Submission regarding DA2020/0666 – 128 Queenscliff Rd, Queenscliff, 2096.

Submission to Northern Beaches Council Regarding DA2020/0666

Extension to the existing building at: LOT 3 DP 16941 - 128 Queenscliff Road Queenscliff

Figure 1 – floor-plans for [REDACTED] and [REDACTED].

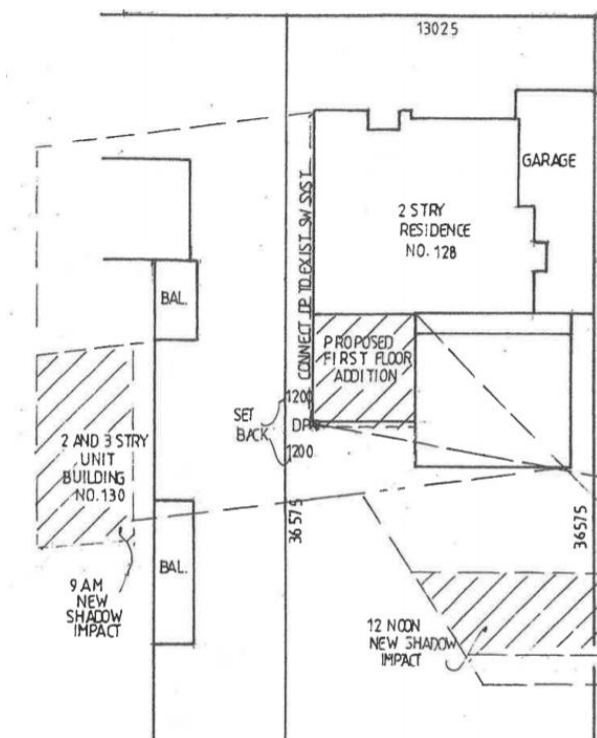
The floor-plans of [REDACTED] and [REDACTED] are identical: Unit [REDACTED] being directly beneath Unit [REDACTED] (see Fig 1). Both balconies face the proposed development. Thus, should the development proceed, the wall height of 128 Queenscliff Rd will increase substantially, eliminating much of the expansive view available to unit [REDACTED] creating a much less attractive outlook - similar to unit [REDACTED].
